**IMPORTANT PRODUCT UPGRADE INFORMATION #160527REV
August 2016**

**SUBJECT: PRODUCT UPGRADE #160527REV
Adding a Ground Wire for the Denso Dash A/C Condenser Fan**

UPGRADE BULLETIN:
160527REV

Adding a ground wire to the Denso dash air conditioning unit's condenser fan harness

Figure 1

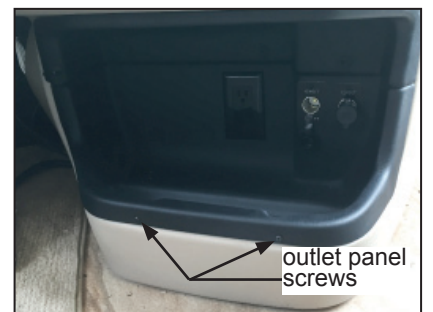
1. Park the motor home on level pavement. Turn off the ignition and remove the key. Place the transmission in NEUTRAL and set the park brake.
2. Locate the 8-pin connector for the harness; this will be labeled "ND HVA". The harness may be located behind the dash, above and to the right of the accelerator pedal. See Figures 1 and 2.

It may be necessary to remove the storage and outlet panel to gain access to the connector. This can be done by removing the eight small screws, as shown in Figure 3.

Figure 4

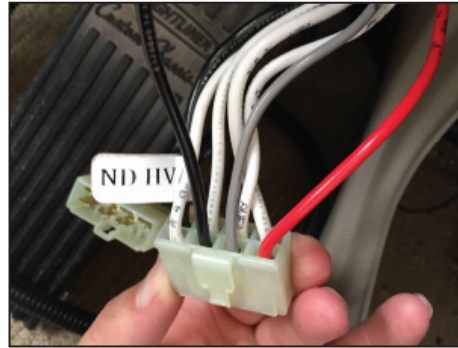
- Referring to Figures 4 and 5, disconnect/separate the 8-pin connector. Insert the female spade connector of the new ground wire (Part # 642552) into the open cavity on the connector. Slightly pull on the wire to ensure the terminal is seated in the connector.

- Locate the ground bar on the front bulkhead, above the accelerator pedal. See Figure 6. Use a 3/8" socket or wrench to remove a nut on one of the "open" or unused studs. Place a star washer on the stud, then slide on the ring terminal attached to the new ground wire. Spin and tighten the nut to snug. See Figure 7.
- Route the all wires back up under the dash and re-secure all wiring with "zip" ties as required.
